CITY OF STOCKTON COMMENTS  
ON  
TENTATIVE WASTE DISCHARGE REQUIREMENTS  
FOR THE  
CITY OF STOCKTON  
REGIONAL WASTEWATER CONTROL FACILITY  
SAN JOAQUIN COUNTY

ADDITIONAL COMMENTS AND FACTUAL CORRECTIONS

Submitted April 25, 2014

Figure 1. Range of TDS in monitoring wells at the Stockton RWCF relative to proposed limitation in Tentative Order.

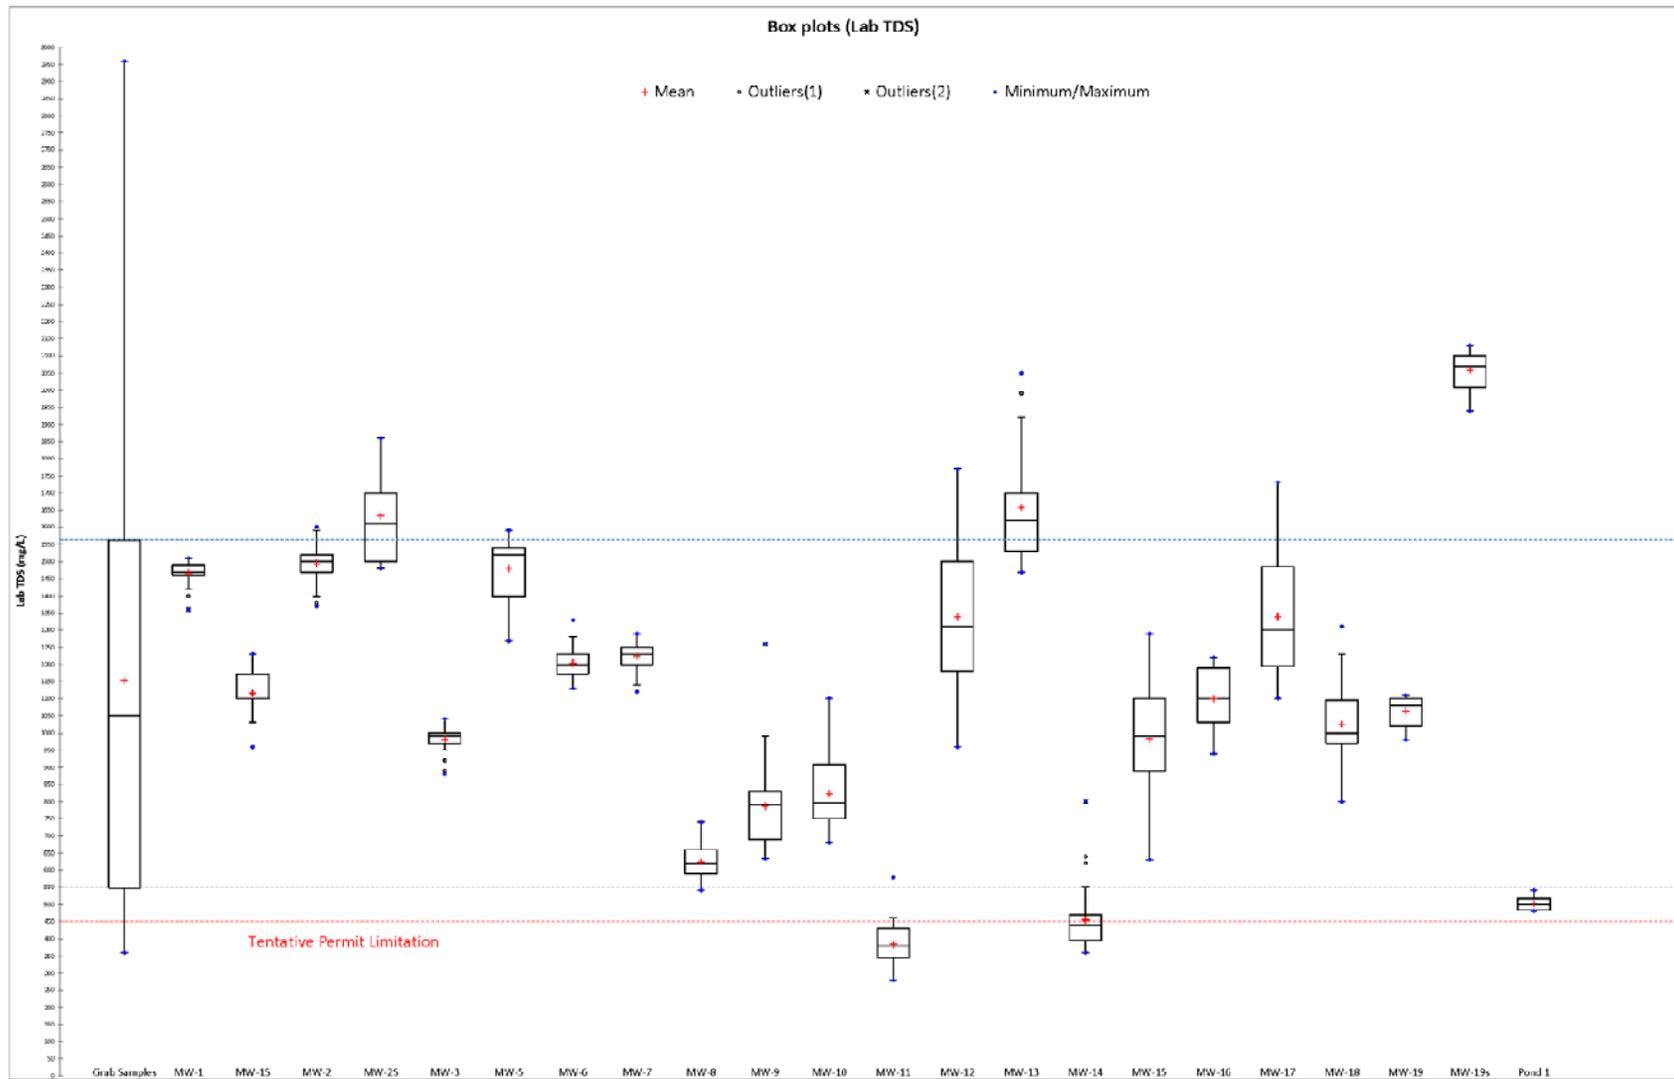
p. 8, Table 6. Groundwater Limitations. The numerical TDS limitation of 450 mg/L will be routinely exceeded in 20 of 21 wells. The City submitted a background groundwater report that characterized TDS in groundwater at the RWCF (see *Background Groundwater Quality Characterization Report*, Condor Earth Technologies, Inc., March 22, 2013). The background TDS interquartile ranged from 548 mg/L to 1563 mg/L with a median concentration of 1,050 mg/L and a mean value of 1153 mg/L. The mean RWCF value agrees well with typical background TDS independently measured for the Delta Sub-basin (see Page F-73 in Section 5, which cites the natural TDS background average as being 1190 mg/L). The City’s statistical analysis (see **Figure 1**) has demonstrated that a 450 mg/L limitation is likely to be routinely exceeded. Similarly, the City’s statistical analysis (see **Figure 2**) has demonstrated that a 2,000 µmhos/cm limitation is likely to be routinely exceeded. By specifying limitations that will be routinely exceeded, the Regional Board creates unnecessary complications for the Discharger’s reporting and public relations.

The City requests the addition of a footnote to the TDS limitation in Table 6: Natural background quality is known to have exceeded this TDS limitation at all 21 monitoring points.

Figure 2. Range of EC in monitoring wells at the Stockton RWCF relative to proposed limitation in Tentative Order.

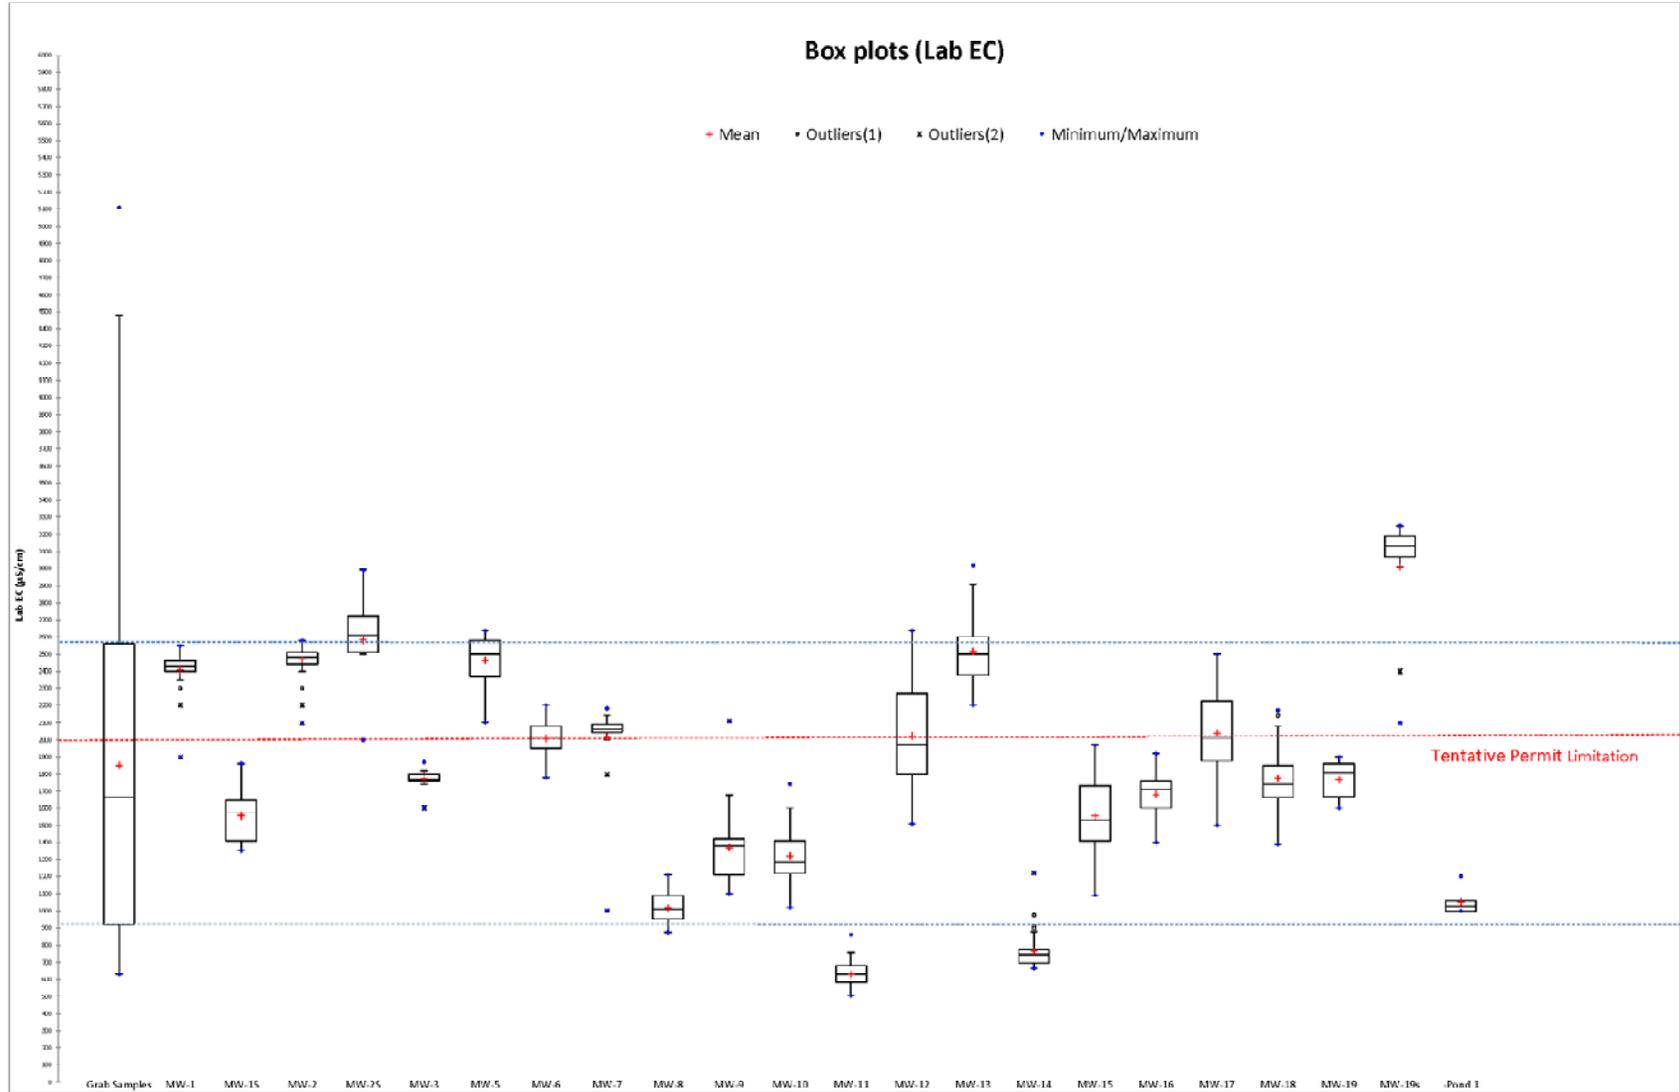
The City requests the addition of a footnote to the Electrical Conductivity @ 25°C (EC) limitation Table 6: Natural background quality is known to have exceeded this EC limitation at 11 of 21 compliance monitoring points.
